Carolina Power & Light Company

SERIAL: NLS-86-365

SHEARON HARRIS NUCLEAR POWER PLANT
UNIT NO. 1 - DOCKET NO. 50-400
CLASSIFICATION OF CONTAINMENT ISOLATION VALVES

CLASSIFICATION OF CONTAINMENT ISOLATION VALVES

VALVE ALIGNMENT TABLE
PRINCIPLE MODES OF ECCS OPERATION

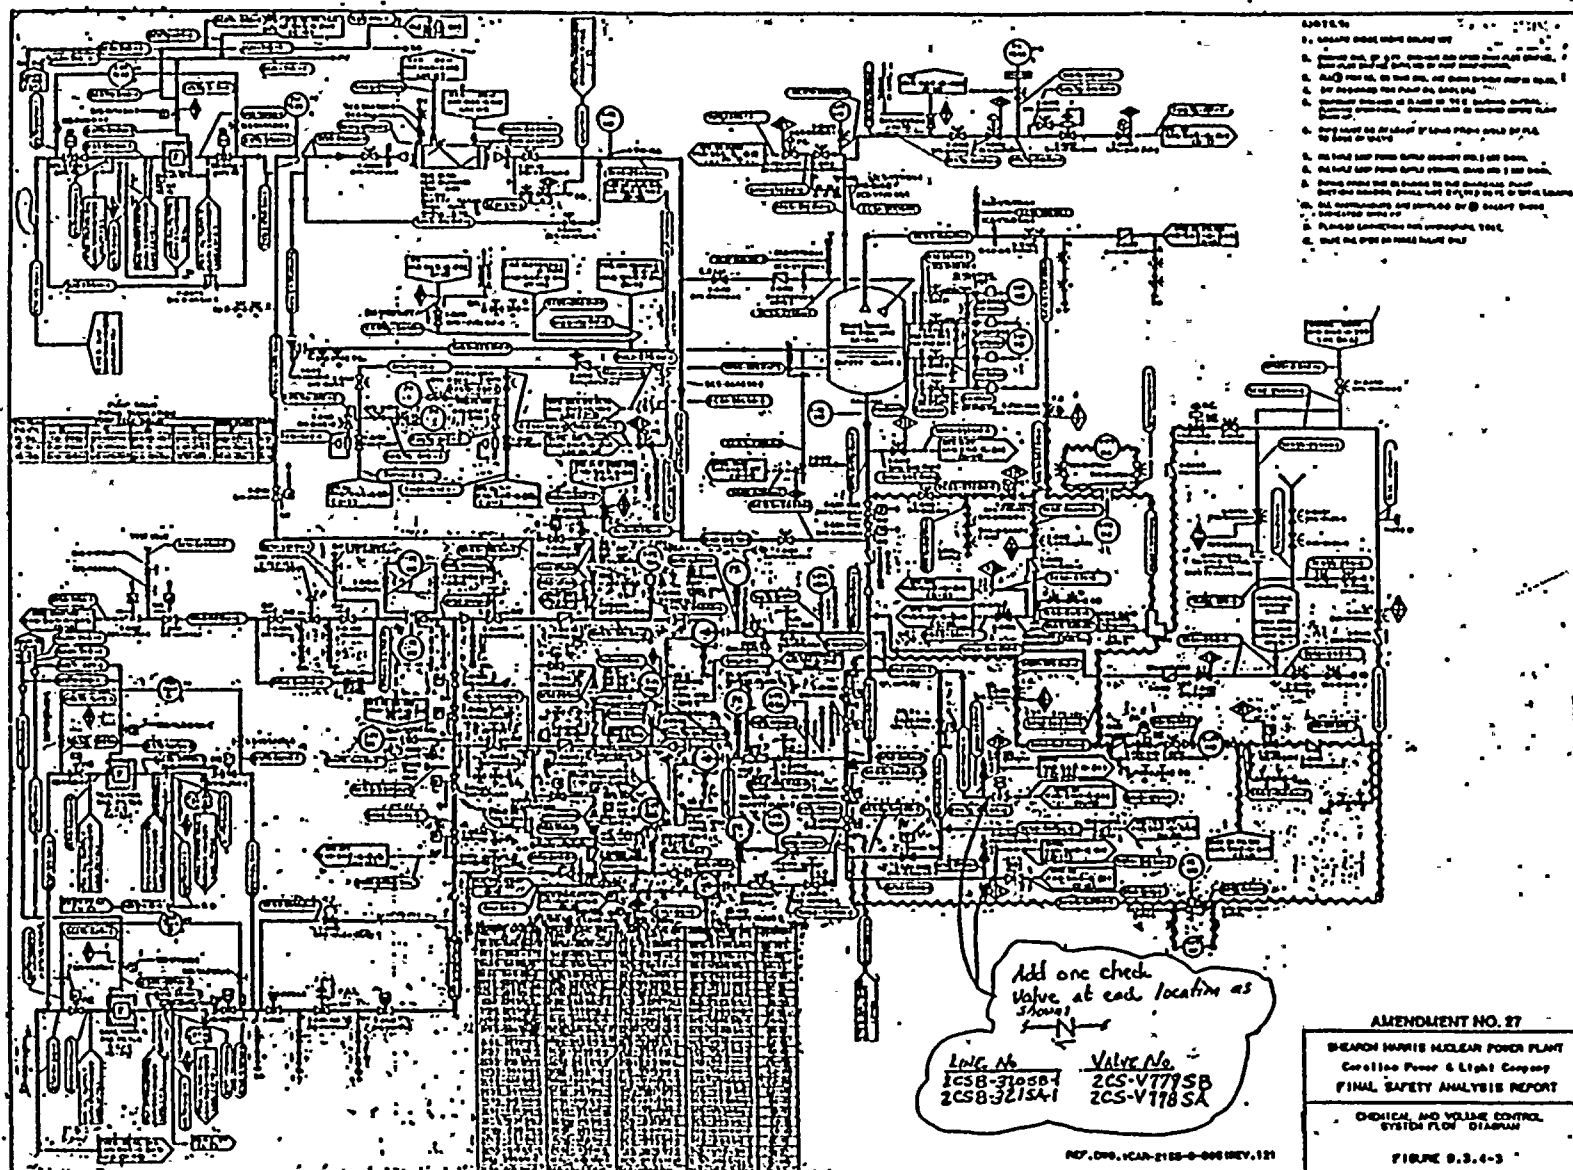
* Valve 7A can be closed in lieu of 7B. Valve closure prevents RHR pump run-out.
